RE: Comment Response for the Teton County Landfill ET Cap Evaluation – Existing Data Review and Cost/Benefit Assessment

Forsgren Associates has received your comments regarding the *Teton County Landfill ET Cap Evaluation – Existing Data Review and Cost/Benefit Assessment* and is addressing your comments below.

Teton County Landfill ET Cap Evaluation

Existing Data Review and Cost/Benefit Assessment

Figure 1. Monolithic ET Cover

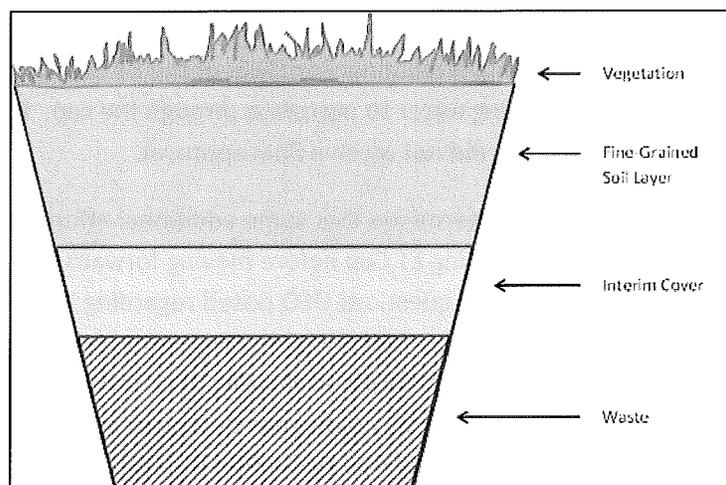
- 2) *Pg 2: Figure 1 is not referenced anywhere in the text. Is this figure necessary?*
 - a) Figure 1 was included in the report to illustrate the general design of an ET cap to provide clarification to a possible reader that is not familiar with landfill caps.

- A reference to Figure 1 was added to the document in Section 1.1.
- 3) *Pg 2: How did you determine the average cover depth is 1.4 feet? This does not coincide with Table 1, please clarify.*

Figure 2. Example Soil Moisture Retention Curves

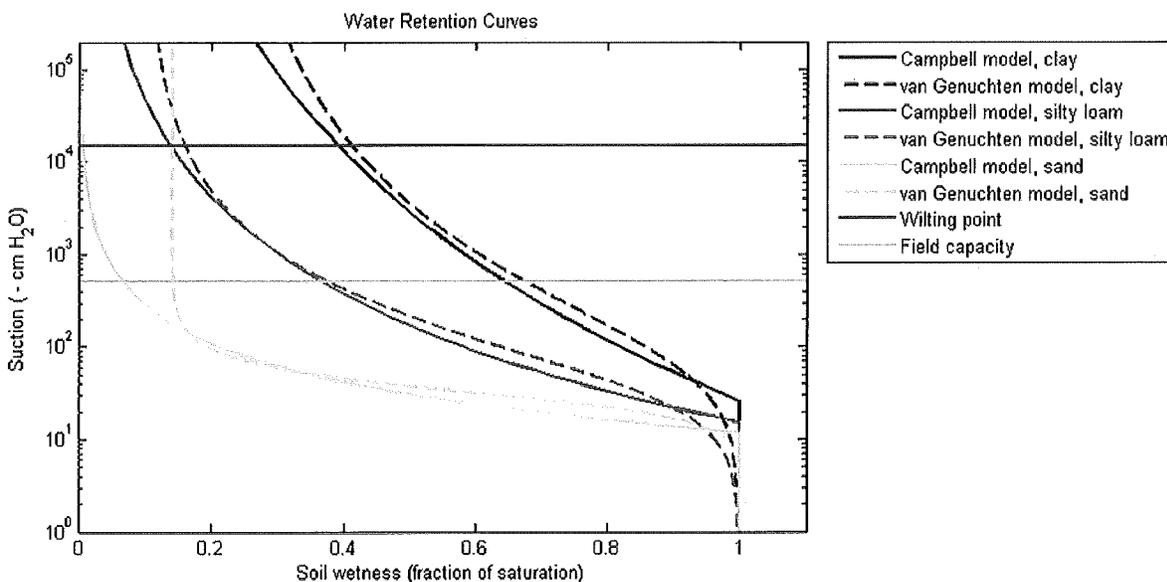
- 4) *Pg 3: Current cover depth figure is in Appendix C not B.*
 - a) Correction was made to the document as requested
- 5) *Are soil moisture retention curve necessary and will the data collect/analysis provide these?*

- a) The relationships between soil moisture and unsaturated flow parameters (i.e., soil suction and unsaturated hydraulic conductivity) as represented by the soil moisture retention curves are necessary for predicting water movement through the cap materials by computer modeling. The data collection and analysis in the current scope does not include this effort; it was shifted to the Additional Services Section during revisions to our agreement due to comments from DEQ regarding validating the existing ET cap. However, as described in the Additional Services, additional sampling of representative soils and subsequent laboratory testing will provide sufficient data to determine the moisture retention properties of representative soils.

- Added text to Section 2.2 of the report.
- 6) *If the 2007 boring logs are located, will this reduce the number of test pits required?*
- a) Yes, if the 2007 boring logs are located and sufficient information is available to determine the characteristics and variability of soils by location, then the scale of any further investigations could be reduced to primarily focus on collecting samples of representative soils.

Existing Cover Exhibit

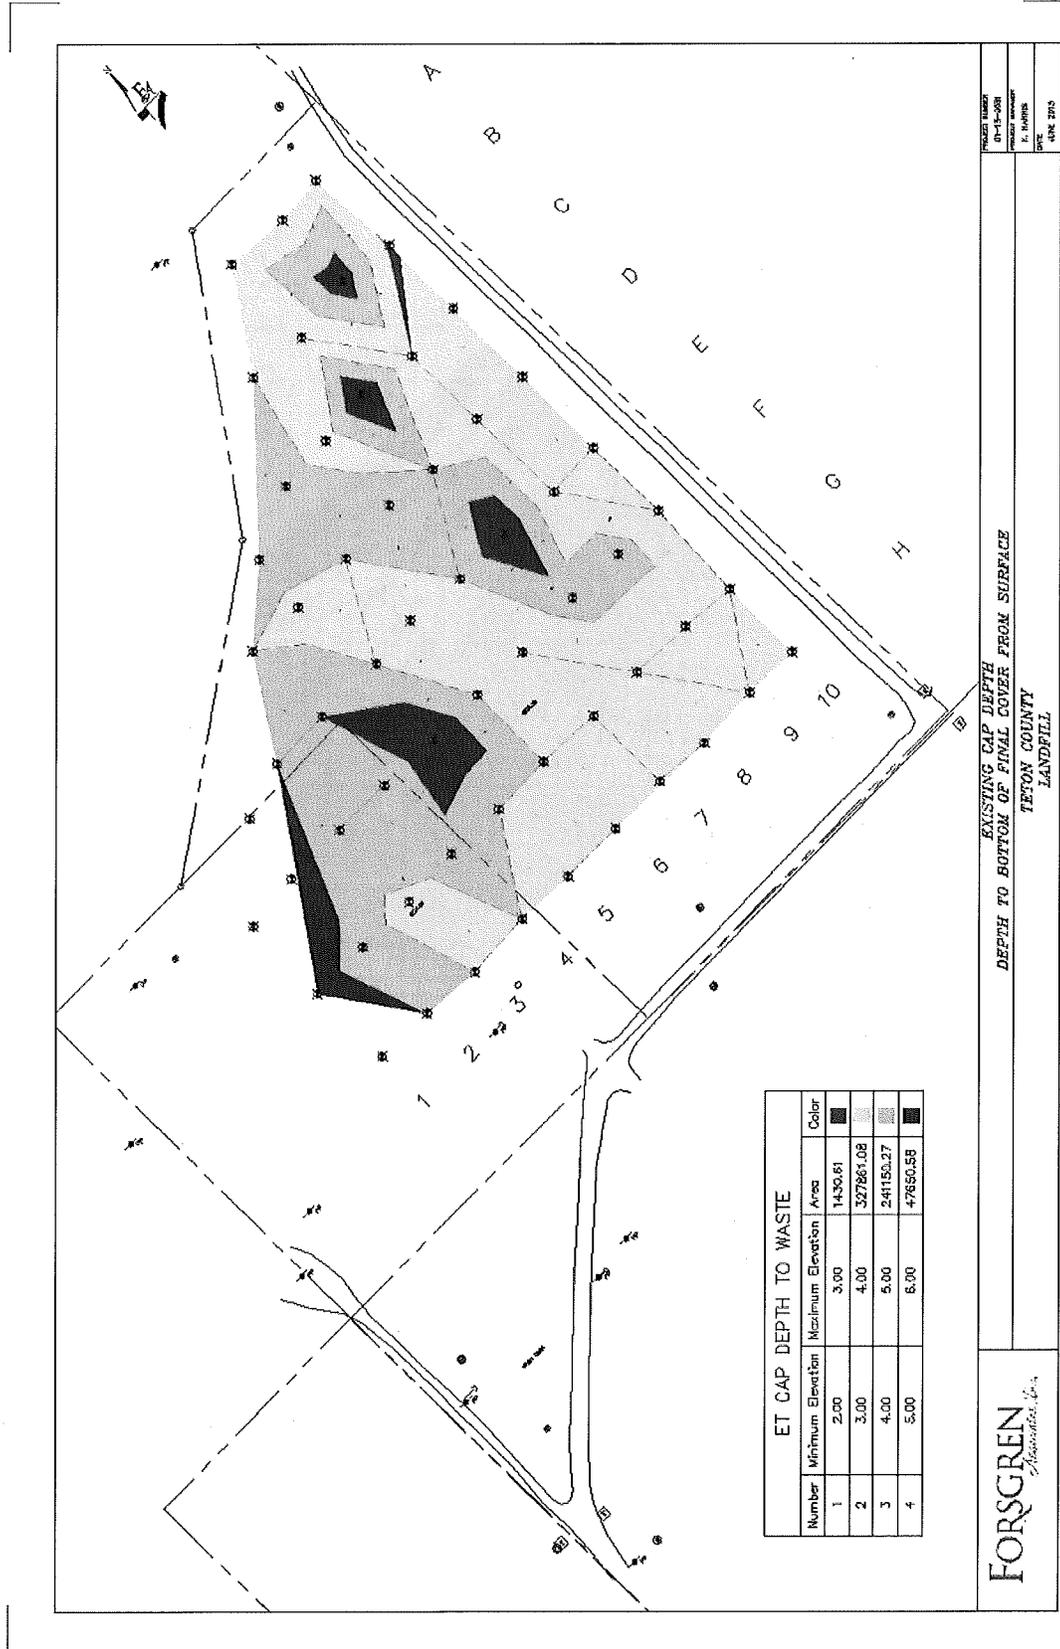
19) Pg 24: Please clarify the depths, are these depth to trash or depths of each layer-what is the starting point?

- a) The depths shown in this exhibit are depths to the bottom final cover from the surface. Added description in title block of the exhibit.

Drainage and Grading Exhibit

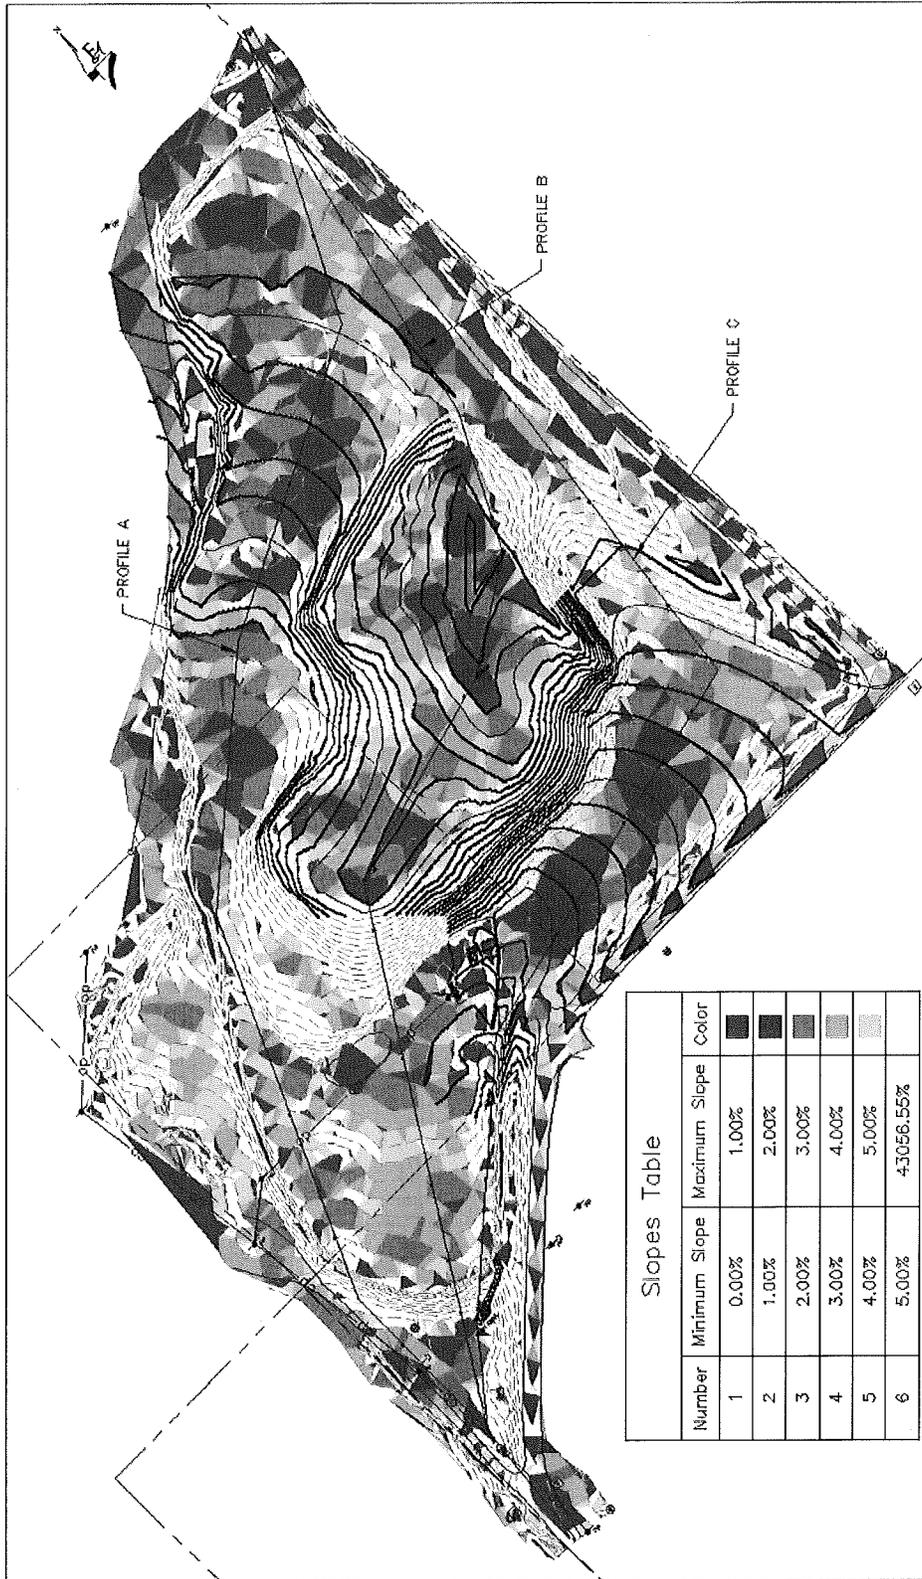
18) Pg 23: Include a legend for the slope analysis

- a) Legend added as requested.

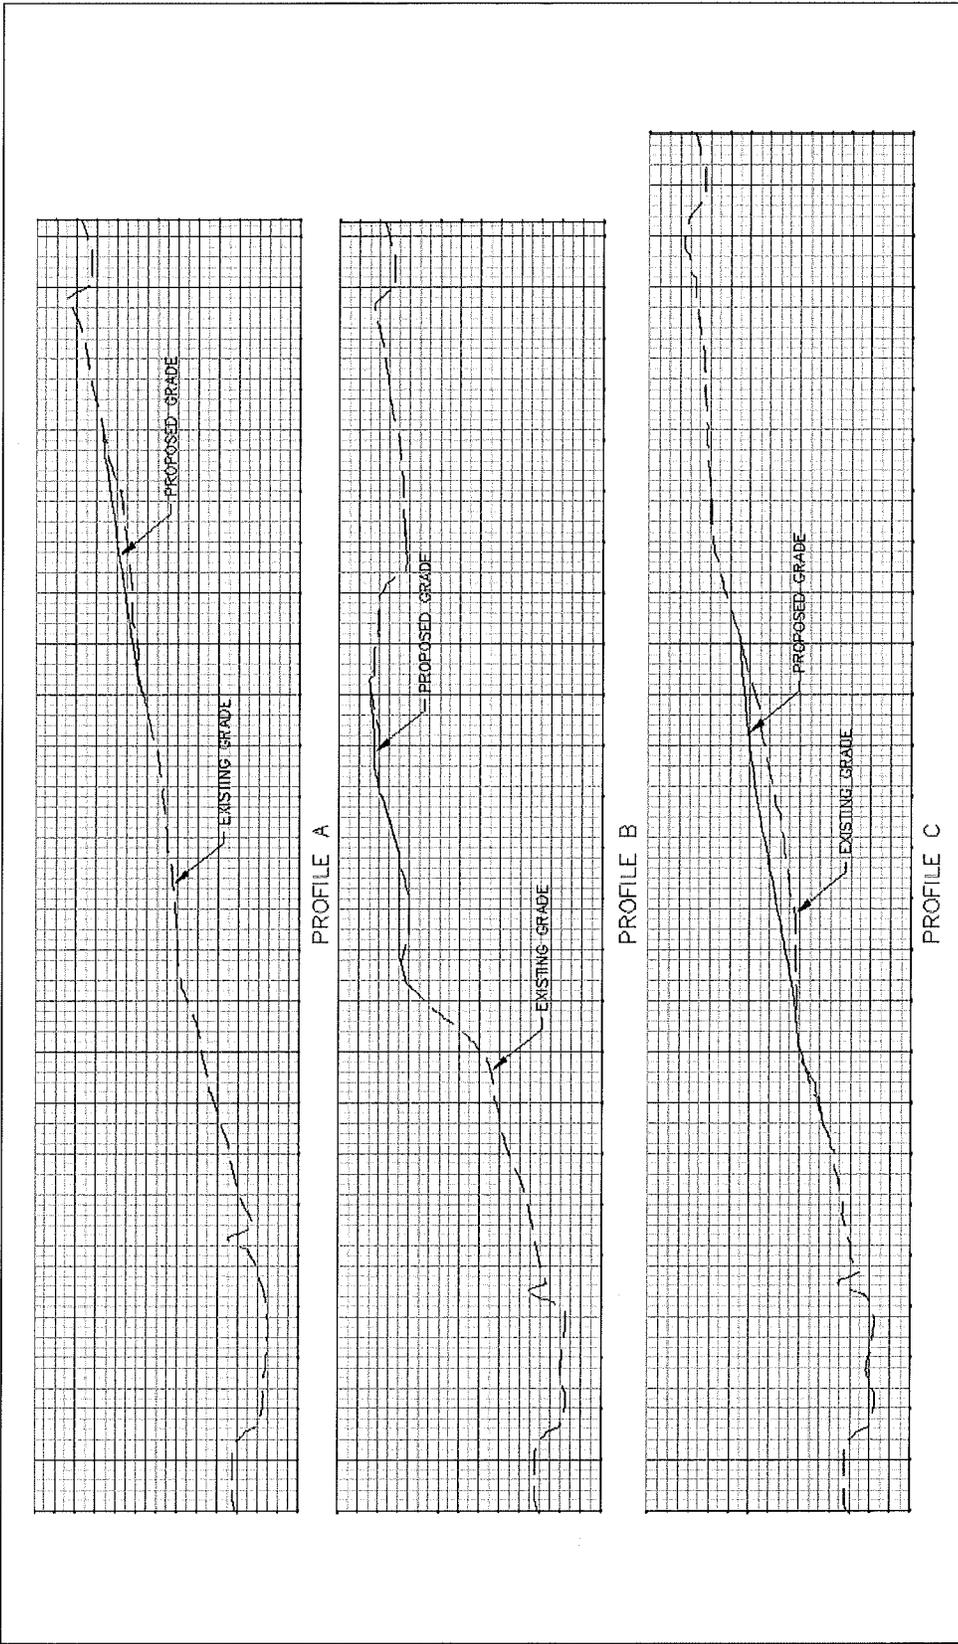
20) Pg 25: Is this proposed grading? If so, please label.

- a) This is the proposed grading, enlarged the description of the exhibit in the title block.
